## **Product Change Notice (PCN)**

PCN Number: PCN-0450022R-01

Product(s) Affected: PJ-074-SMT-TR

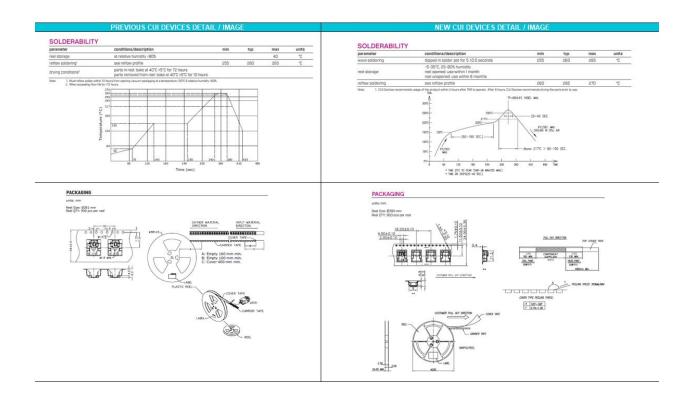
Description of Change: Product re-engineered for improved manufacturability and production yield. See image below as reference for product changes. Cosmetic differences may be visible and do not affect the form, fit or function of the product.

PR	REVIOUS CUI DEVIC	ES DETAIL / IMAGE		NEW CUI DEVICES DETAIL / IMAGE		
	MATERIAL	PLATING				
terminal 1	brass	gold flash	DESCRIPTION	MATERIAL	PLATING/COLOR	
terminal 2	copper alloy	gold flash	terminal 1	brass	gold flash	
terminal 3	copper alloy	gold flash	terminal 2	copper alloy	gold flash	
plastic	PA6T or equivalent		terminal 3	copper alloy	gold flash	
	o qui raione		housing	PA10T (UL94V-0)	black
